HOUSING AUTHORITY OF THE CITY OF MILWAUKEE
Willie L. Hines, Jr. Secretary-Executive Director

Quote #9905
Request for Services Pricing
Roof/Garage Repair/Replacement – 3211 North 20th Street

ADDENDUM #1
June 13th, 2023

Garage Roof - 3211 N. 20th St.

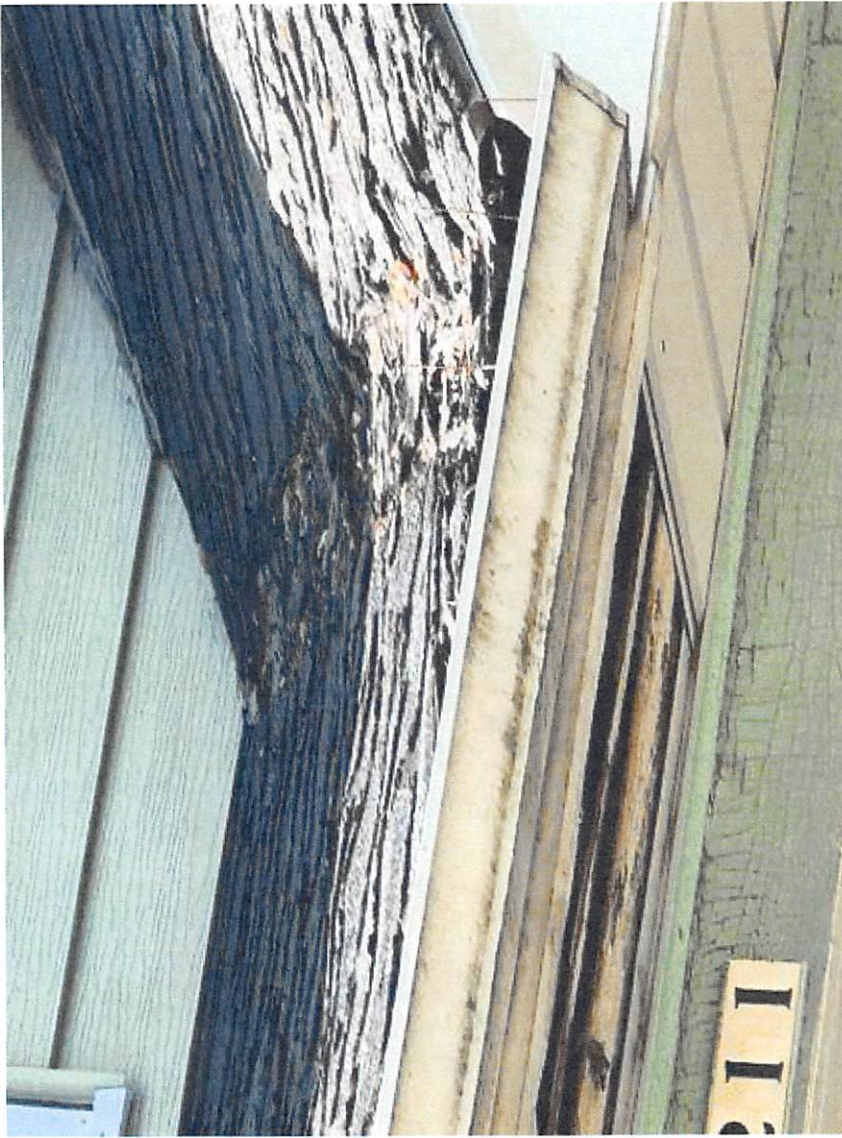
1. Garage Roof Replacement \$ _____
2. 2 spots, one by the front door (east side) where the soffit is rotted/damaged all the way through to the point where you can actually see daylight. 2nd spot iso n the southside; the SW location seems to just be missing soffit panels.
\$ _____
3. The existing chimney on the south side can be eliminated in its totality.
\$ _____
